LAKE PONTCHARTRAIN, LA. AND VICINITY
LAKE PONTCHARTRAIN BARRIER PLAN

DESIGN MEMORANDUM NO. 2, GENERAL
ADVANCE SUPPLEMENT
INNER HARBOR NAVIGATION CANAL WEST LEVEE
FLORIDA AVENUE TO IHNC LOCK

LMVED-TD (NOD 13 March 1967) 3d Ind
SUBJECT: Lake Pontchartrain, La. & Vicinity, Lake Pontchartrain Barrier
Plan, Design Memorandum No. 2 - General, Advance Supplement,
IHNC West Levee - IHNC Lock to Florida Avenue

FIGURE 4-4

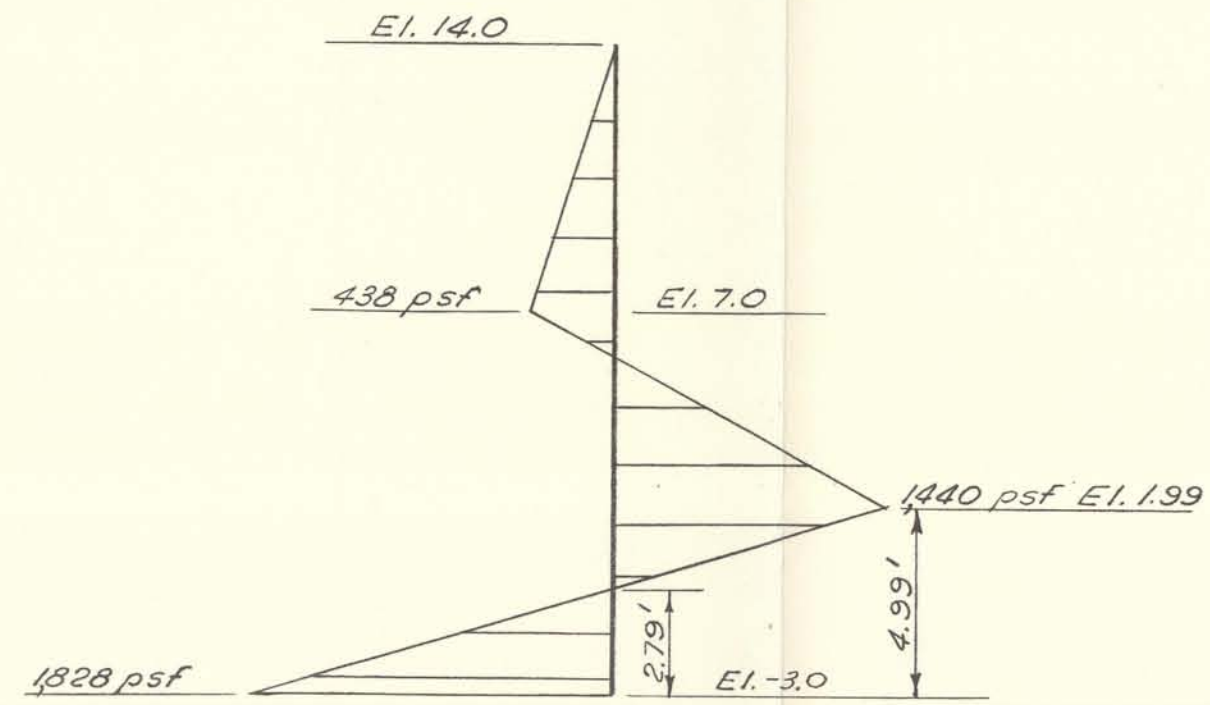
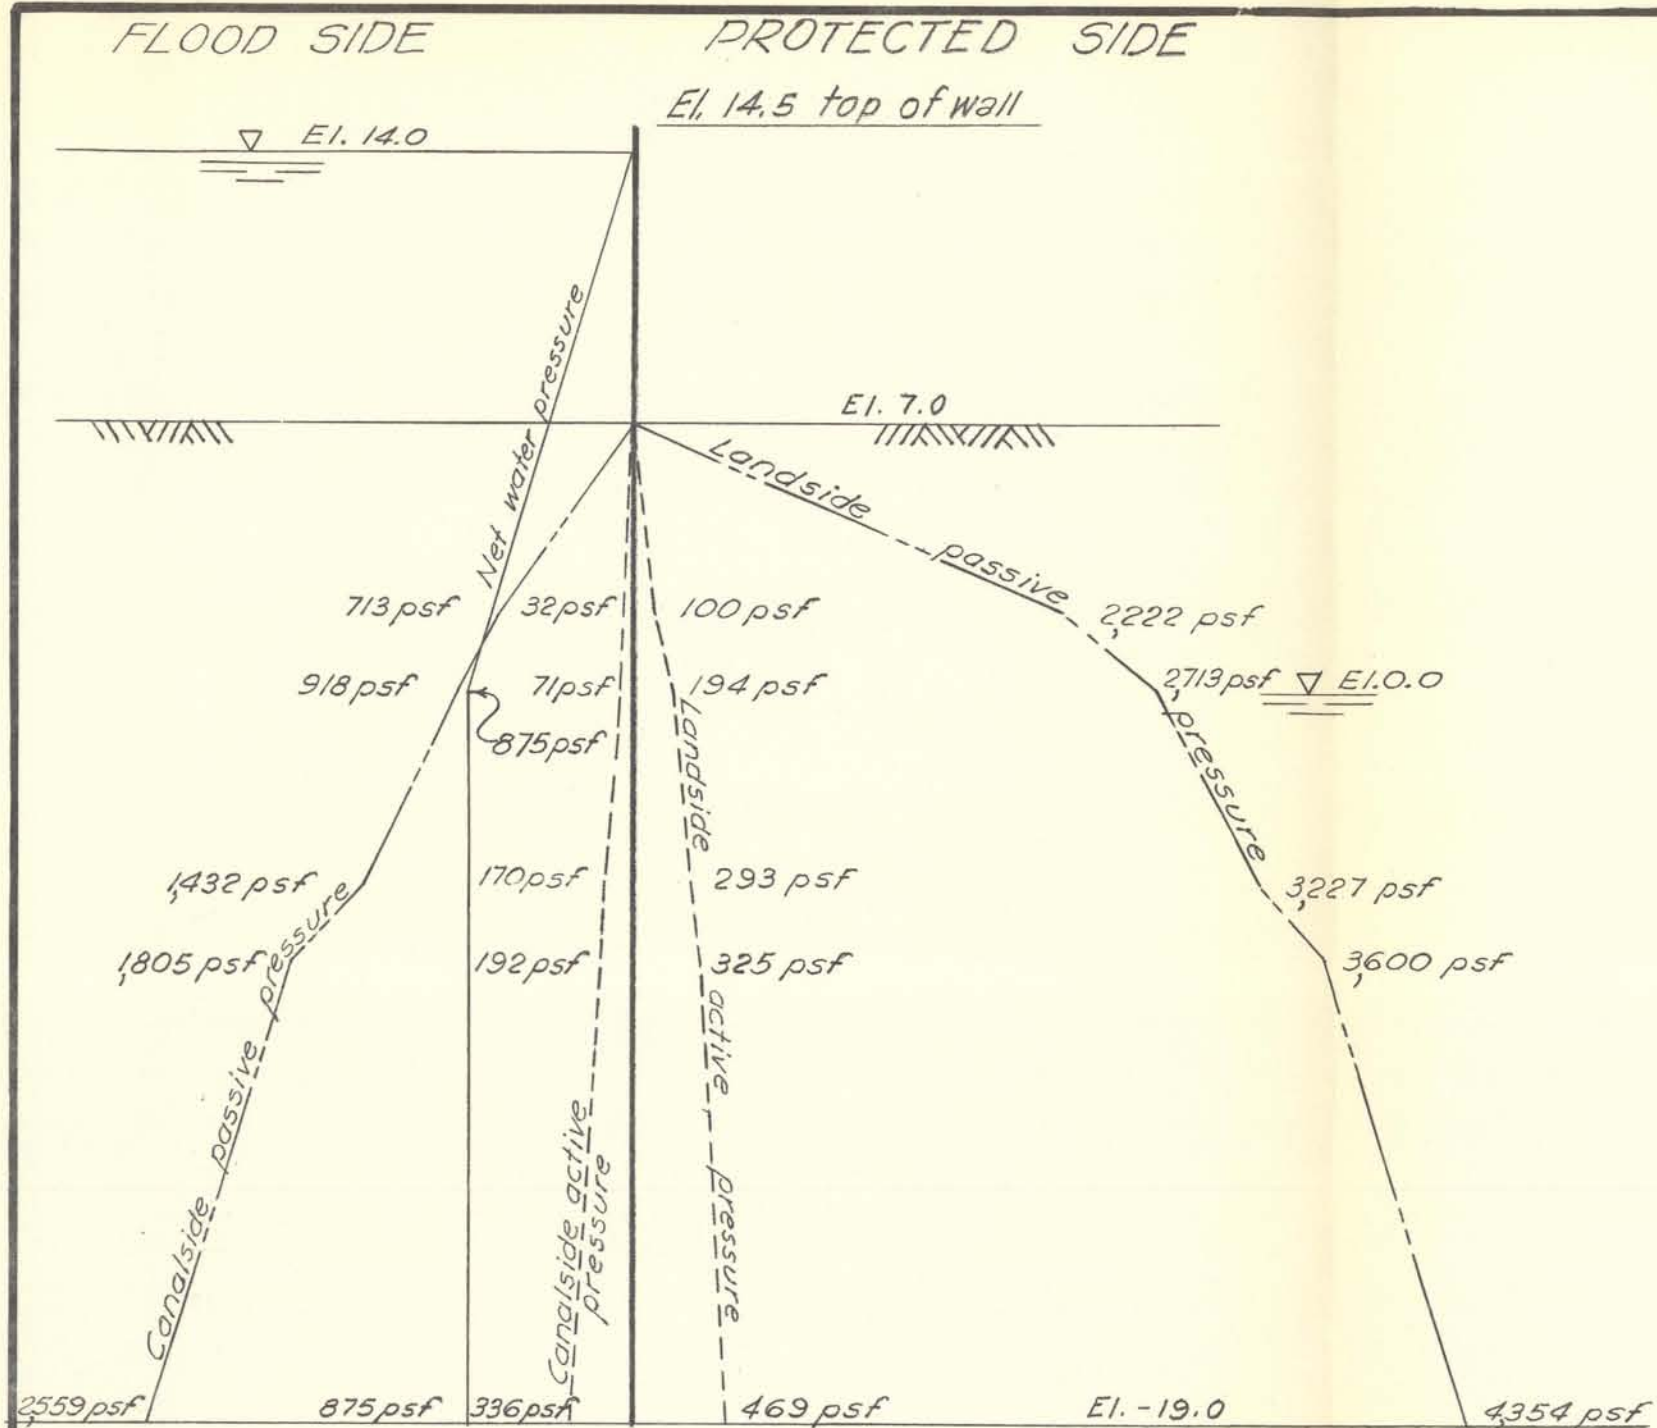
c. Based on subparas 5a and 5b above, it appears that I-type floodwalls may not be feasible in the reaches indicated, with the possible exception of the reach from sta 49+68 to sta 52+94.75, due to excessive bending moments, stresses, and/or deflections. In the reaches from sta 59+30 to sta 59+49.5, sta 59+96.75 to sta 64+05, and sta 64+05 to sta 65+39.75, batter piles were provided to reduce the deflection of the wall. However, the design of the wall in these reaches neglects the effect of the batter pile on the stresses, penetration, and deflection of the sheet piling. This procedure is too conservative. It appears that in the reaches listed in subpara a above, it will be possible to use batter piles to reduce stresses and deflection in the wall or in some of the reaches a T-type wall on piles could be used. Where batter piles are used, their influence on stabilizing the wall and on the loads applied to the sheet piling should be properly considered.

Figure 4-33

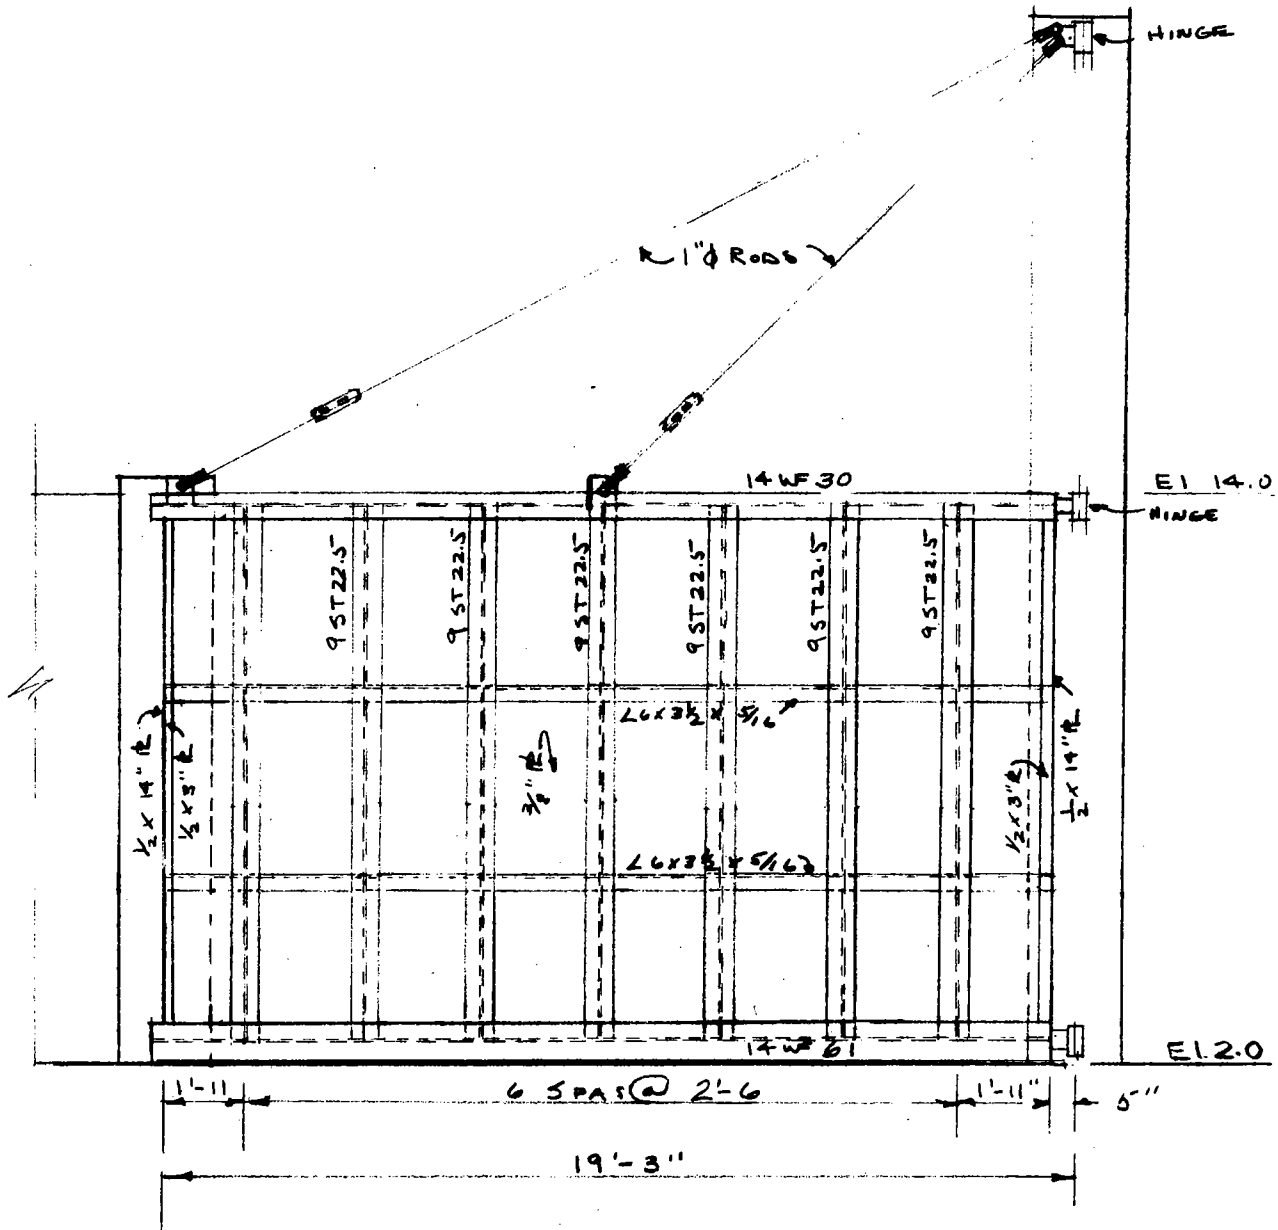
8. Figure 4-33. Consider eliminating the 1-inch tie rods and designing the hinges for the greater reactions.
